Gahcho Kué Mine

**March 2018 Water Licence Amendment
Applications (MV20015L2-0015
and MV2005C0032)**

Environment and Climate Change Canada

July 2018

Figure 2.5-1: Modelled PM_{2.5} 24-hour Predictions at Air Quality Stations Relative to CAAQS, the Keeping Clean Areas Clean Threshold, and Background Concentrations

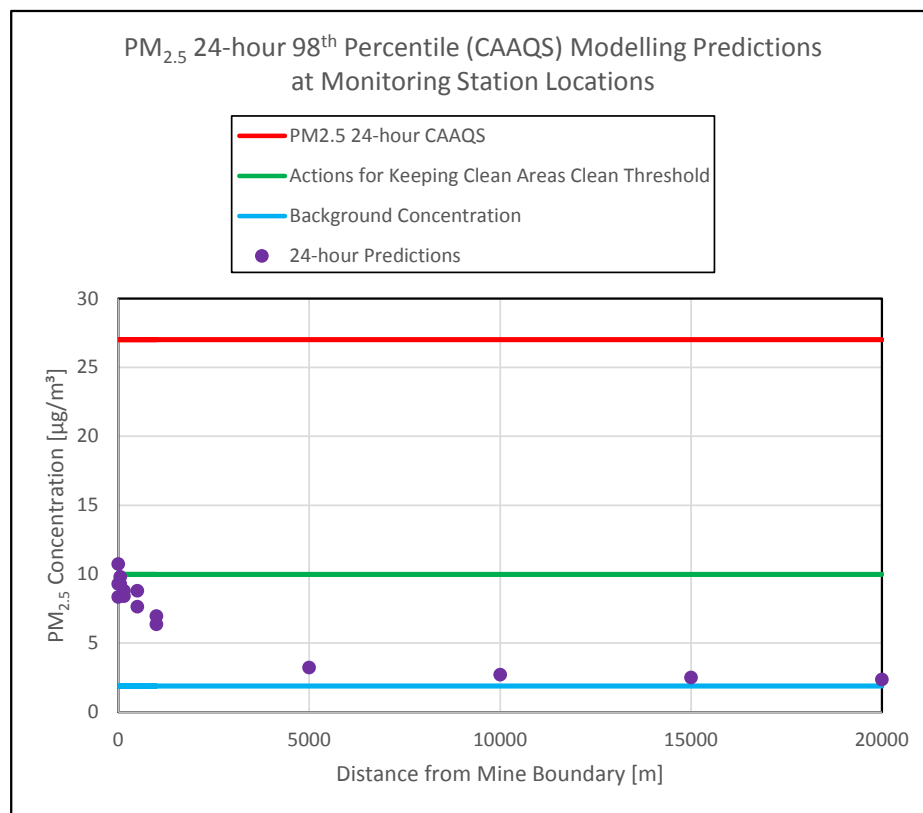
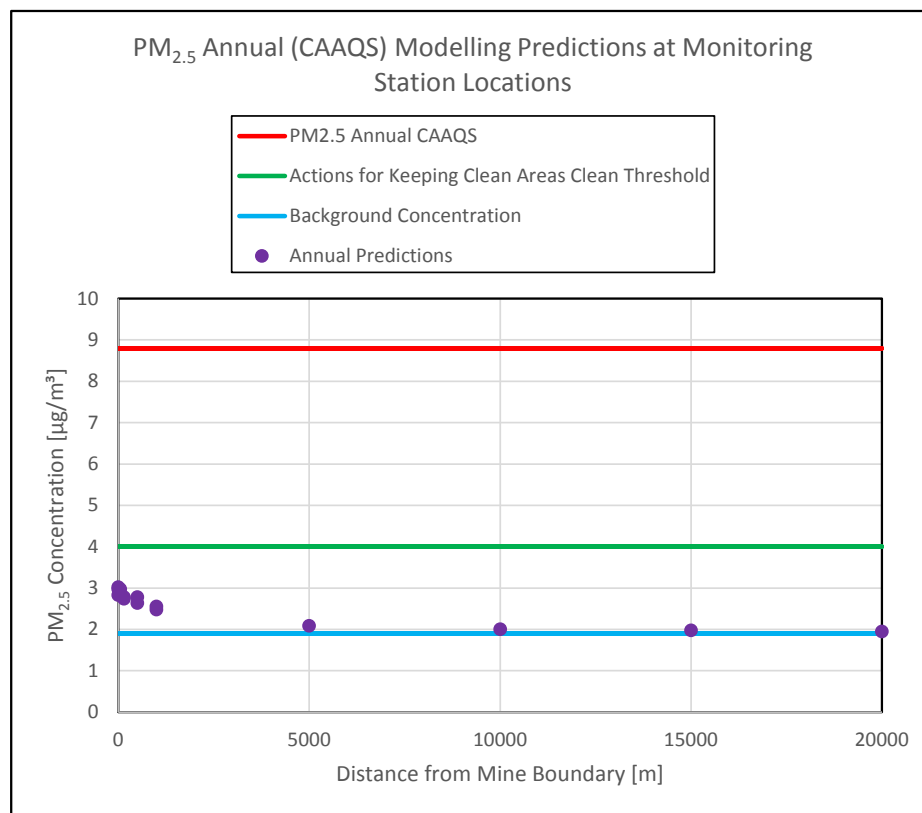
Consider how NO₂ and PM_{2.5} emissions from the Project may affect ambient air quality as compared to the CAAQS for NO₂.

Figures 2.5-1 and 2.5-2 illustrate that the modelled PM_{2.5} concentration predictions attenuate rapidly within 1 km of the Mine boundary, and are comprised primarily of background concentrations (i.e., non-Project ambient background concentrations) at and beyond 5 km from the Mine boundary. All predicted concentrations at the monitoring stations are well below the PM_{2.5} CAAQS:

- 24-hour PM_{2.5} concentration predictions are below the ‘Green’ Keeping Clean Areas Clean threshold immediately past the Mine boundary (Figure 2.5-1); and
- annual PM_{2.5} concentration predictions are below the Keeping Clean Areas Clean threshold at and beyond the Mine boundary (Figure 2.5-2).

Air quality in the North Slave air zone with respect to PM_{2.5} will not be significantly affected by Project emissions.
